# UNITED STATES PATENT AND TRADEMARK OFFICE

**Office Action Summary****Application No.**

10/554,182

**DETAILED ACTION**

FIG. 7

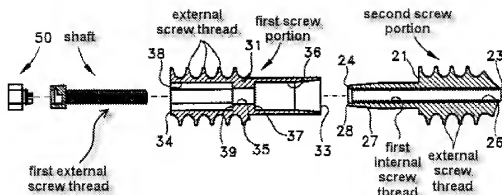
10. Claims 16-19, 23, and 24 are rejected under 35 U.S.C. 102(b) as being anticipated by Bramlet (5,827,285, cited by applicant). Bramlet teaches

a. Concerning claim 16, 17, and 19, a longitudinal shaft having a head and a longitudinal axis; a first screw portion rotatable about said longitudinal axis; a second screw portion rotatable about said longitudinal axis independently of said first screw portion, wherein said first and second screw portions each have an external screw thread having a first thread direction and configured to engage a bore formed in the first and second members (see Fig. 2 in Bramlet and modified Fig. 7 below).

b. Concerning claim 18, 23, and 24, element 250 can be considered a lock nut; the shaft would be at least flexible to a small degree; first and second members are bone (see Fig. 2);
